Planning Board Meeting March 12, 2024 – 7:00 PM Town Office Conference Room

Formal Site Plan – Jonathan MacLean, JEM Property Management, LLC – 1505 Maine Street – Map 15 Lot 7

Response to Comments 1505 Maine Street Poland ME

On behalf of Jem Property Management LLC, Terradyn Consultants, LLC is pleased to submit responses to peer comments 1505 Maine Street Property project. The information enclosed was prepared in response to comments from Sebago Technics provided on September 12, 2023.

DATE: 89/9/2023 SCALE: 1"=20' DESIGNED: JOB NO: 22-138 SHEET C-2.0

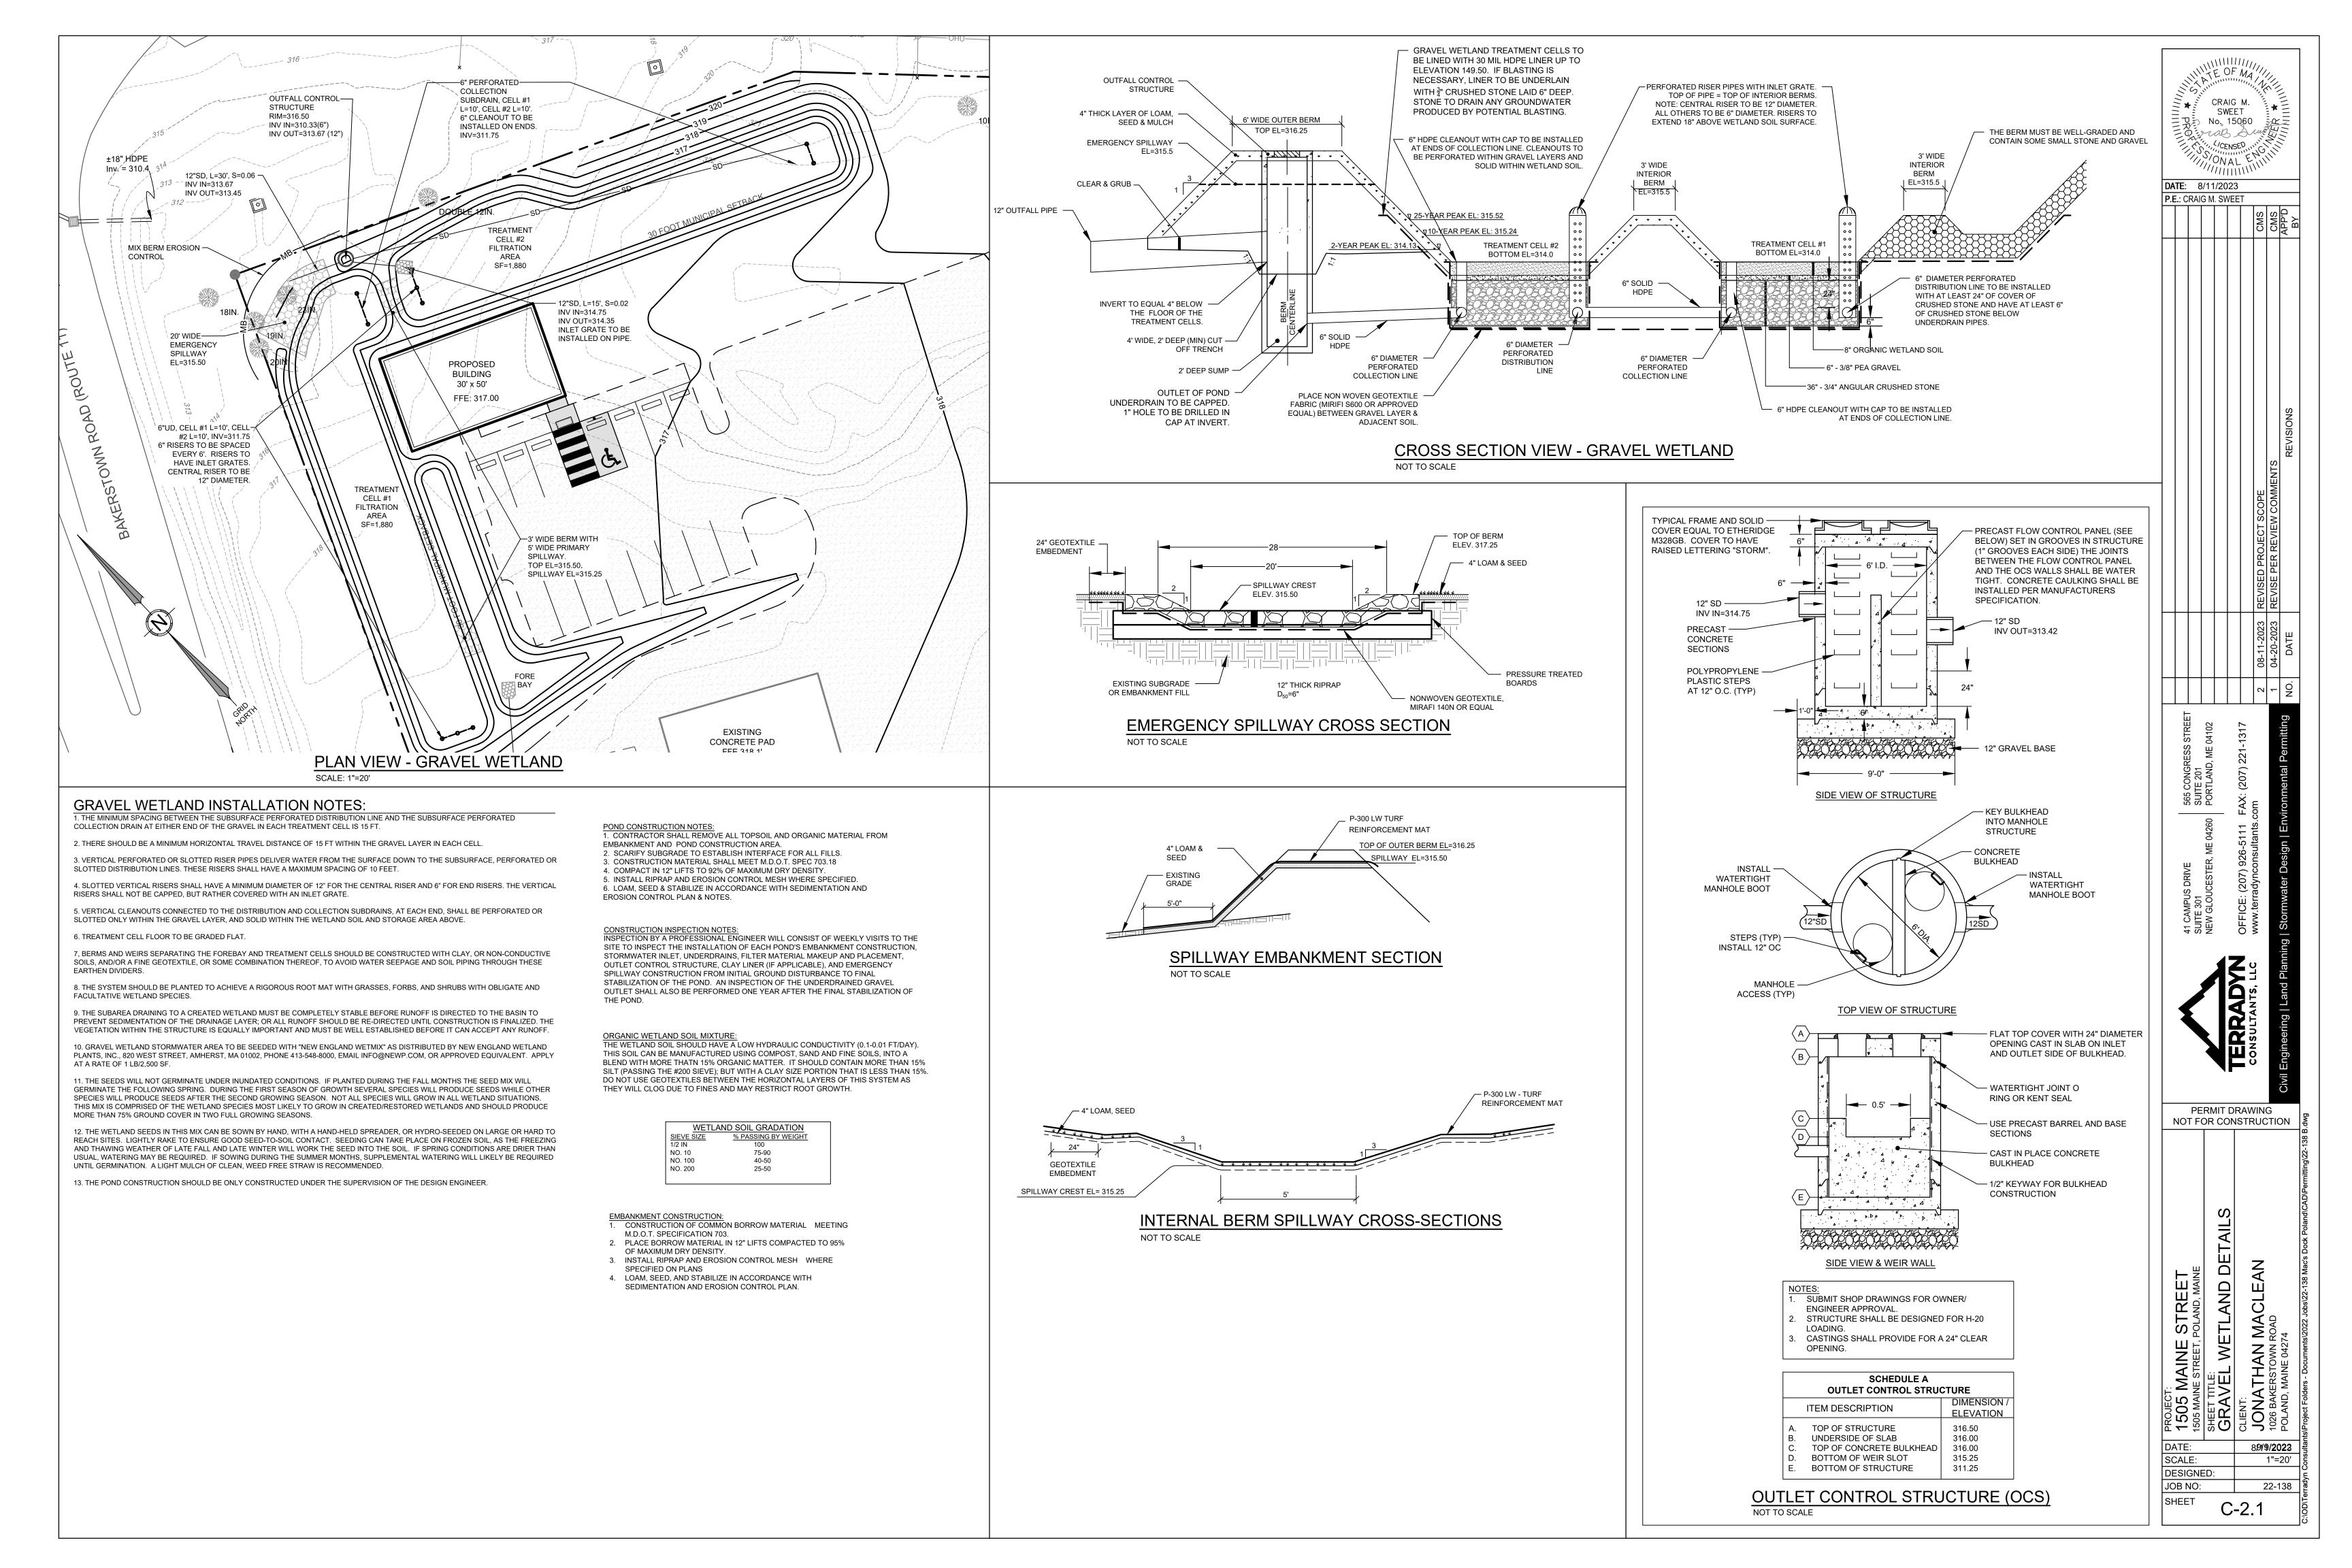
The project avoids impacts to adjacent wetlands, and the plan set includes erosion control notes and details on sheet C-3.0. Locations of proposed erosion and sedimentation controls are shown in plan view on sheet 2.0.

SCALE: 1"=20' DESIGNED: 22-138 SHEET C-2.0

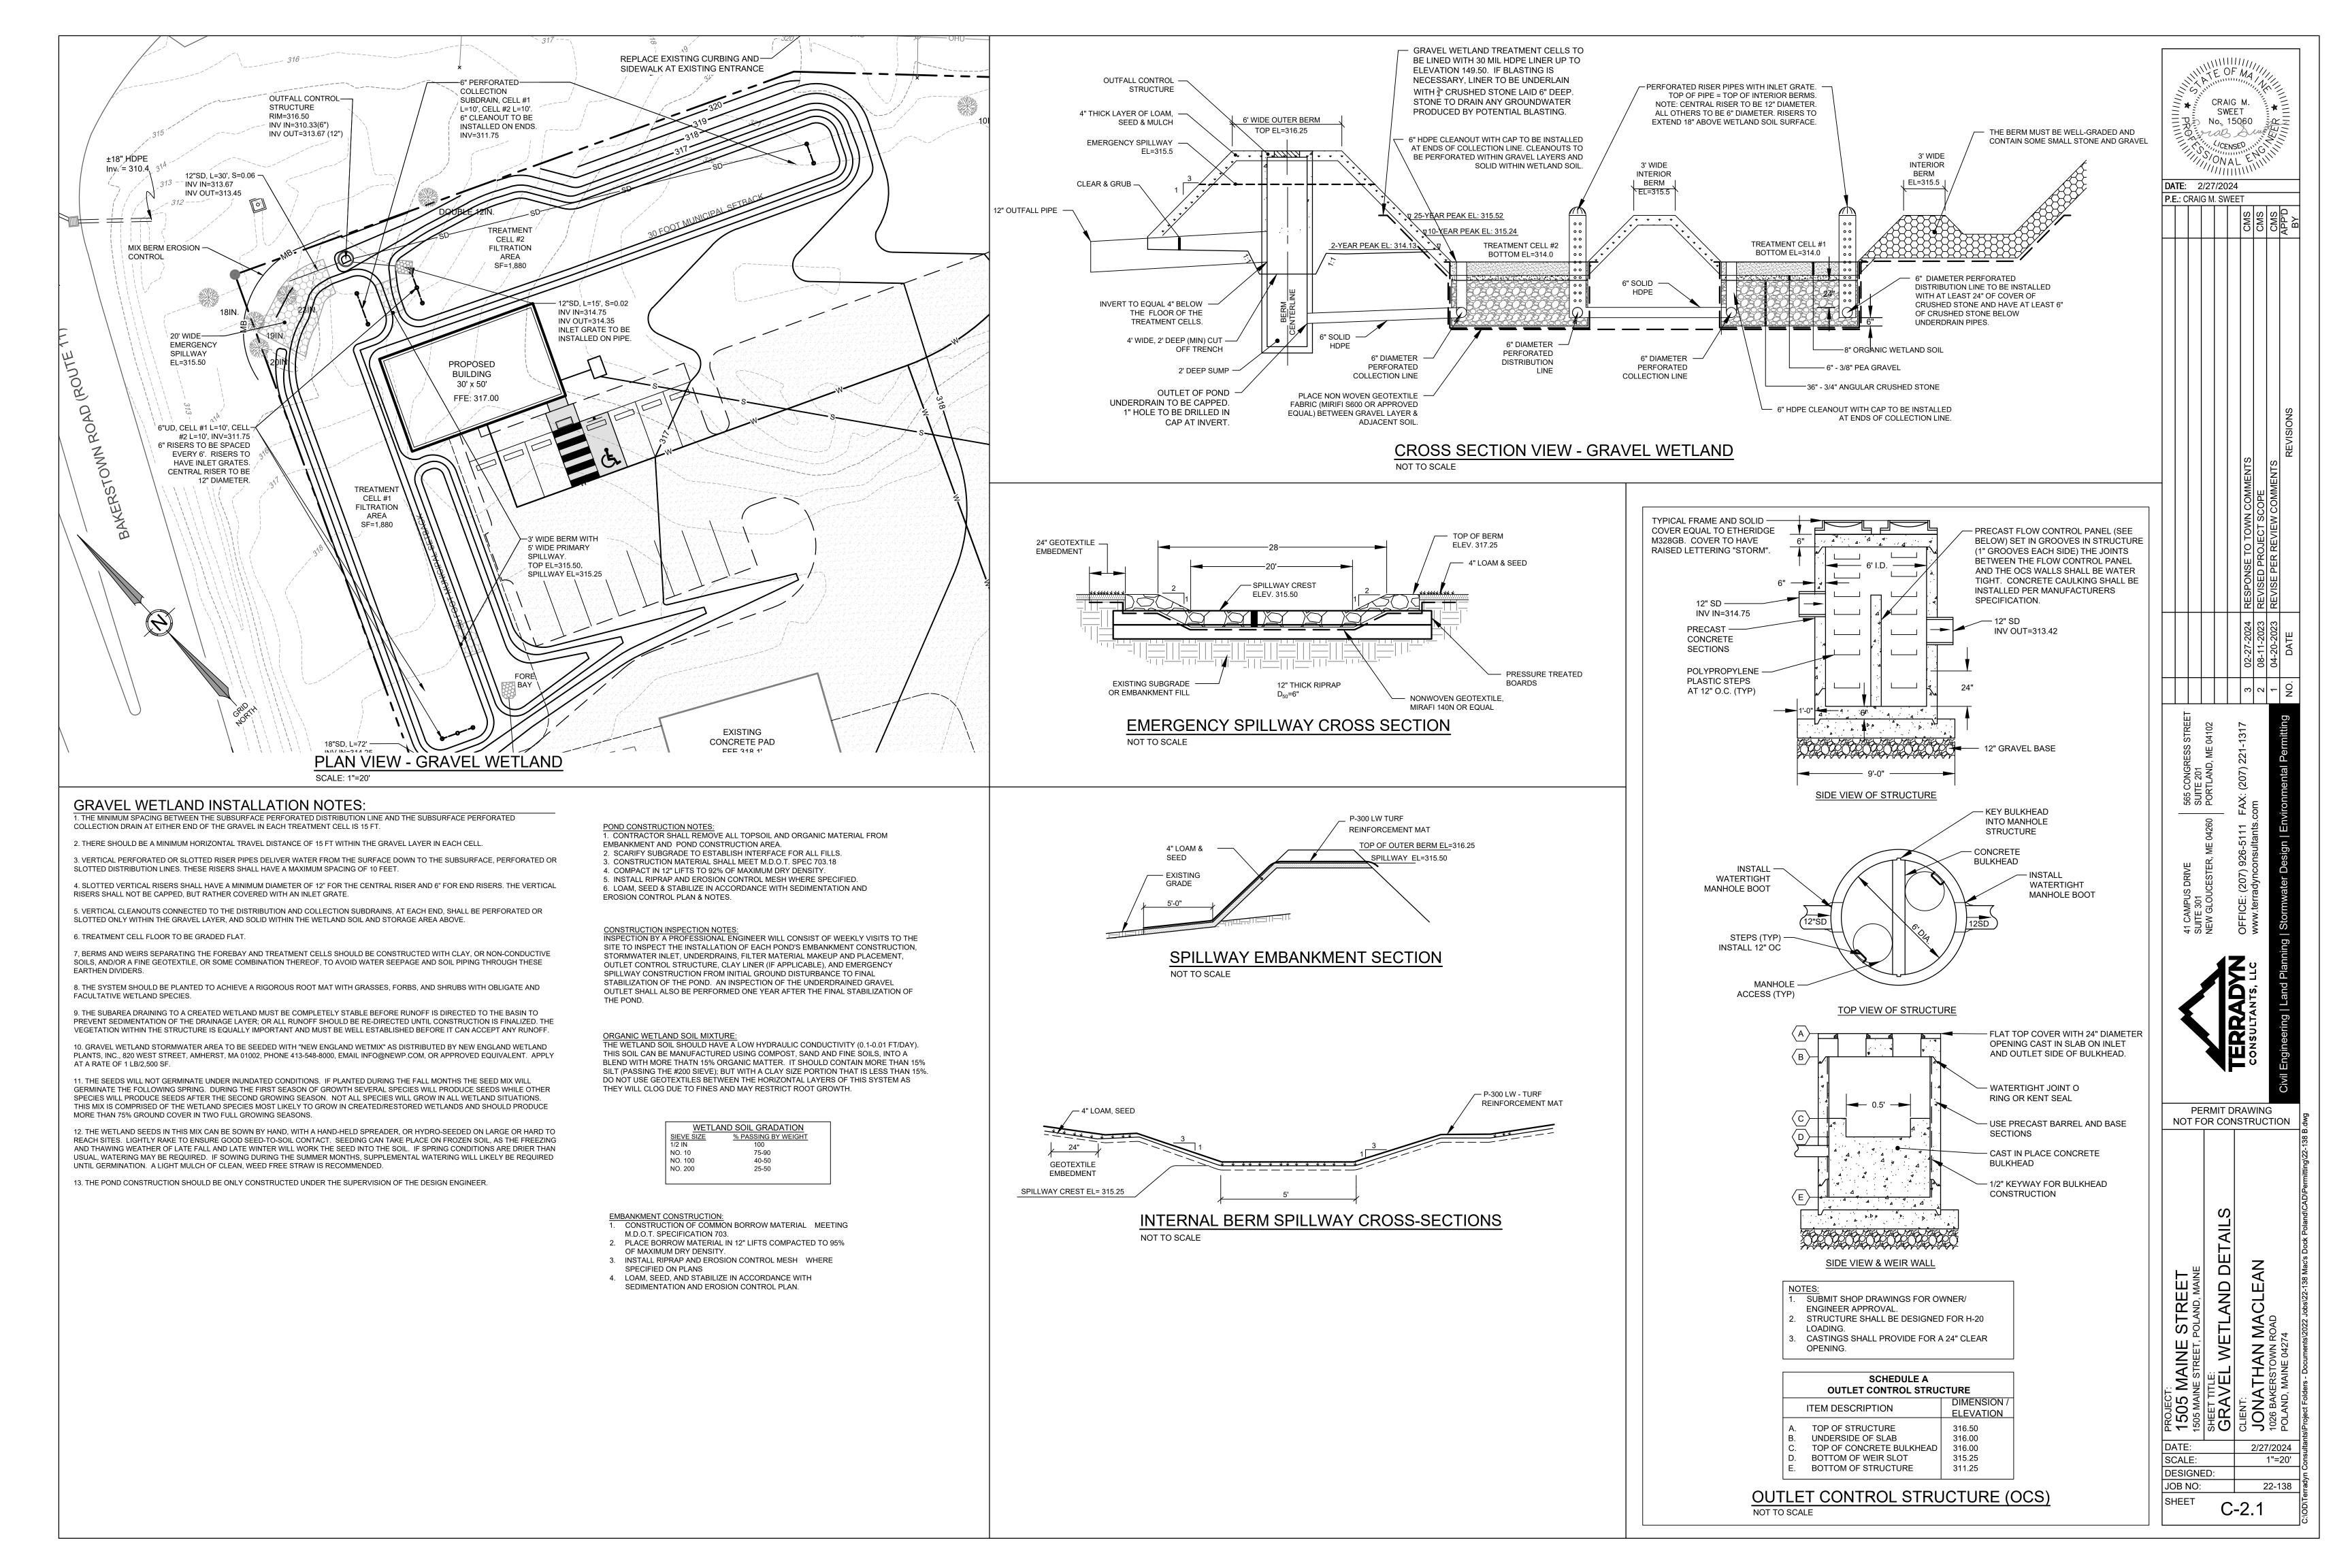
The project avoids impacts to wetlands, and the plan set includes erosion control notes and details on sheet C-3.0. Locations of proposed erosion and sedimentation controls are shown in plan view on sheet 2.0.

The water service connection into Maine Street is shown on the Grading Plan sheet C-2.0.

The septic system design layout is included on Sheet C-2.0 and shown ten feet off the property line abutting the ball field. A test pit has been performed by Nicholas Adams, LSE #432 that indicates suitable soils for a subsurface wastewater disposal system. However, the initial HHE-200 Form only included wastewater being originated from the building closest to the road corner, and the new plan indicates that the second building will also add wastewater. The HHE form shall be updated, and or include appropriate sizing to include added flows, if necessary, from the new building, size appropriate sewer line (force main?) and then assure the D box is appropriate for both lines of entry. Does the 120gal/day include both buildings or just the first building?
